Addendum 66 – UN Regulation No. 67

**Revision 6 - Amendment 1**

Supplement 1 to the 03 series of amendments – Date of entry into force: 30 September 2021

# Uniform provisions concerning the approval of:

"Figure 3

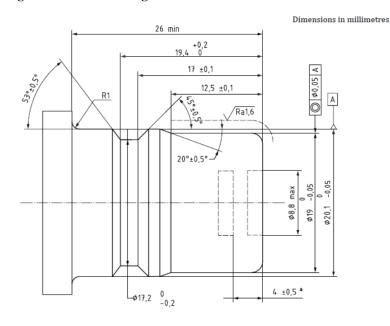
Figure 3, amend the figure title to read:

## Connecting area of the K15 filling unit"
